**Re: NORI EIS Official Comment Form**

We thank you for the opportunity to provide commentary on the Environmental Impact Statement for NORI's plans to test a polymetallic nodule collector system in the NORI-D lease area of the eastern Clarion Clipperton Zone of the Pacific Ocean, between Hawaii and Mexico. Below, please find our commentary. We used the information and format for commentary as provided on <https://www.eisconsultationnauruun.org/>.

## NORI EIS Official Comment Form

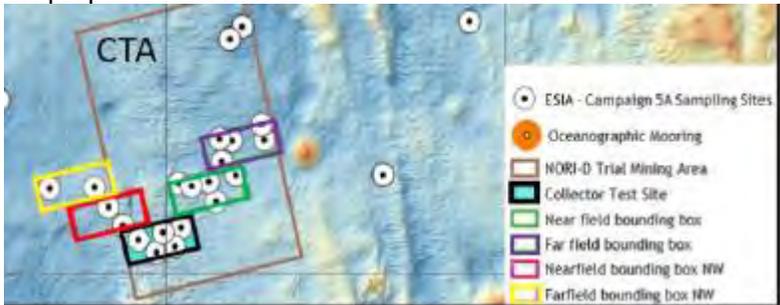
Page 4-9 4.5.1.1 – Table 4-8	This table talks about significance scores allocated to impacts. The Negligible definition indicates “Very high probability that the impacted VEC is well represented throughout the CCZ”. Here again, the absence of biological data means that any statement about representative probabilities is completely unsupported, given there is no evidence in the EIS of any of the biological VECs in the NORI area.  If the “level of detail [required to characterize key environmental attributes] is not available for the collector test as the baseline studies are not yet complete, and there remains a degree of uncertainty around the sensitivity of many of the VECs” then potential impacts cannot be properly assessed.
